**AN ANALYSIS OF THE DESIGN AND PERFORMANCE OF
THE CLAY CAP USED TO CONTROL GROUNDWATER
RECHARGE INTO THE FRACTURED BEDROCK BENEATH
THE FORMER SODIUM BURN PIT (FSDF) AT THE FORMER
BOEING-ROCKETDYNE SANTA SUSANA FIELD
LABORATORY**

William C. Bianchi, Ph.D.

October 5, 2006

Hydraulic Conductivity In Different Units As Related to Particle Size Definitions

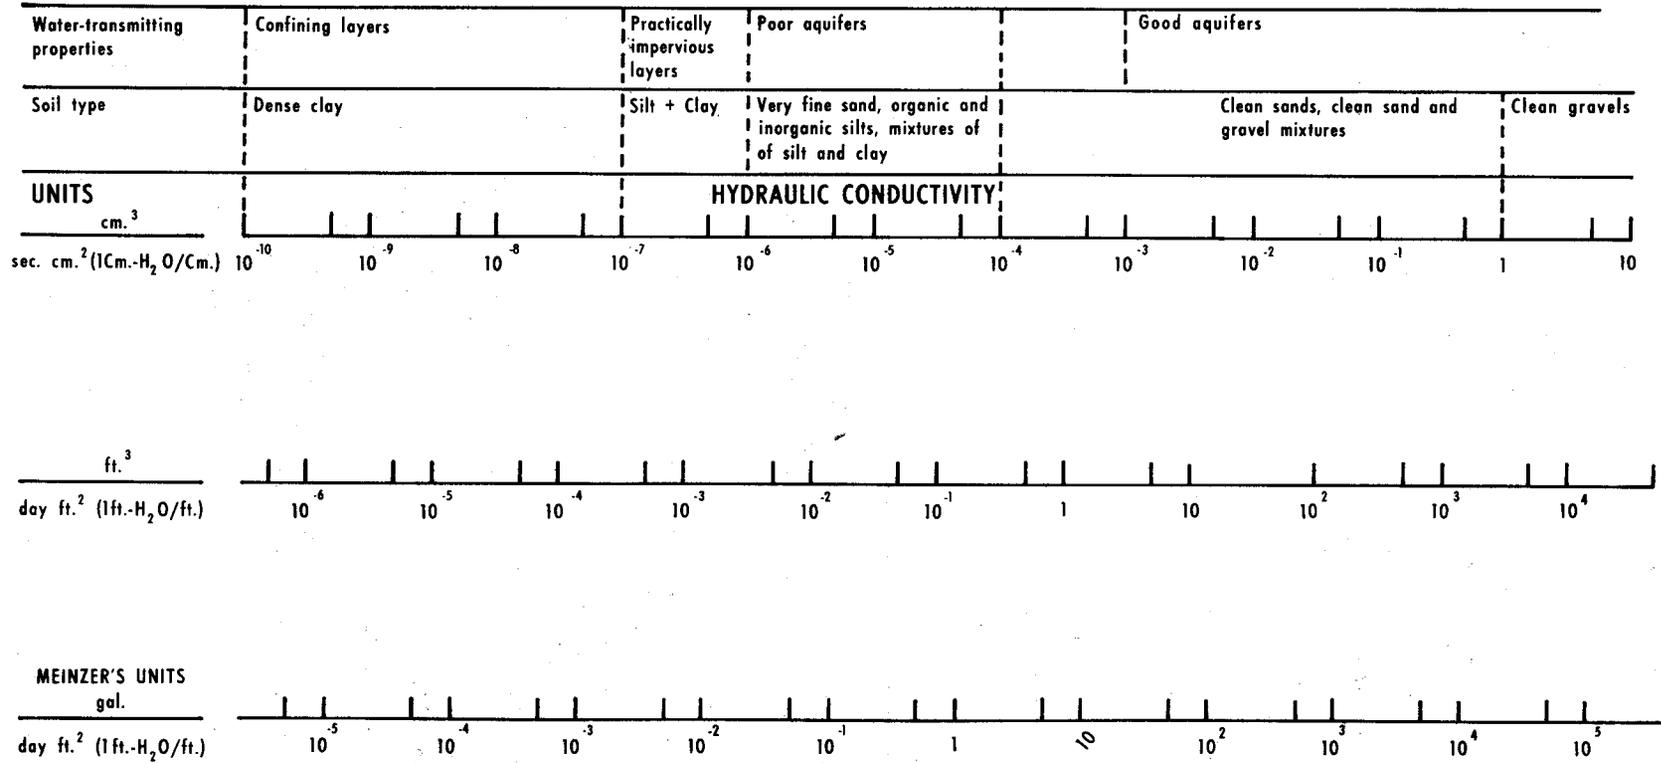
The proposed physical solution now in place designed to isolate the pollutant materials in the bedrock consists of placement of what is defined as a “clay cap”, a soil backfill put in place after the original soil and the pollutants it contained were removed down to the bedrock basement of the pit area (Interim Measure Work plan, July 9, 1999). The thickness of this cap is at least 1 foot and no greater than 12 feet. This backfill was excavated from a barrow pit area on the facility. The laboratory soil particle size analysis (see Infiltration Monitoring Work plan, Former Sodium Disposal Facility, IT Corp. April 14, 2000, appendix A and A1) puts this fill material in the silty clay to silty clay loam soil class according to textural standards (USDA Soil Survey Manual #18). The field water transmission performance of these textural classes as viewed by geohydrologists is shown in Figure 1. As seen here this textural range places the water

transmitting properties in the class of a poor aquifer, not in the impervious range. Again, this cap was meant to prevent future percolation of rainfall into the crack matrix of the bedrock and thus eliminate further downward mobilization of pollutants.
